**Explanatory document for the amended Nordic synchronous area
proposal for additional properties of FCR in accordance with Article
154(2) of the Commission Regulation (EU) 2017/1485 of 2 August
2017 establishing a guideline on electricity transmission system
operation**

Appendix: Results of Public Consultation

Figure 6

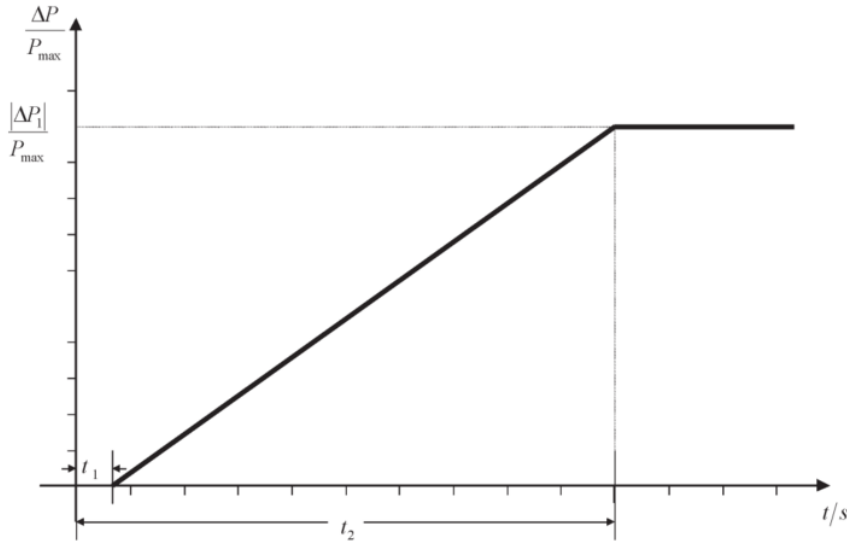
This Figure 6 shows that it is only required to reach 50 % of the activation far later than the current requirement of 50 % within 5s. Since especially at times of low inertia in the Nordic synchronous area a fast FCR-D response is required², the TSOs consider relaxing the current requirement unacceptable for operational security reasons. For that reason, the TSOs propose keeping the existing requirement that “50 % of the upward FCR-D in each subsystem shall be regulated upwards within 5 seconds;”. Article 4(2) of the Proposal reflects this position.
